Product Change Notification

Date Issued: July 19, 2022 **PCN Number:** 511741 Reason for Change: Change to Product Description of Change: This letter is to inform you that our supplier about the additive they use in the Wevo product, they have problem with availability. It informs us about adding a second source for this ingredient. There'll be no negative impact to product performence as a result of this change. Reason for Short Notice: **Special Request** Assessment of Change: First Article Inspection Planned Implementation Date: July 29, 2022 Sample Availability Date: July 19, 2022 **Internal Molex Qualification Date:** July 19, 2022

An examples of the products where the material is used:

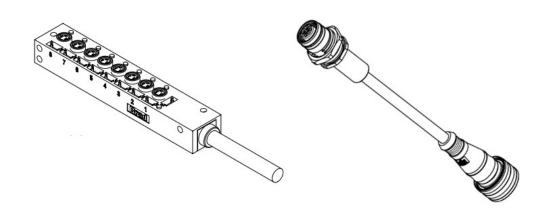
- According to information from our supplier about the additive they use in the Wevo product, they have facing problem with availability. They adding a second source for this ingredient. No change in the final properties of the product were detected. The viscosity range will remain the same.
- Product Impact
 - No impact to fit, form or function of product itself
- Part Number Impact
 - see attached impacted parts list
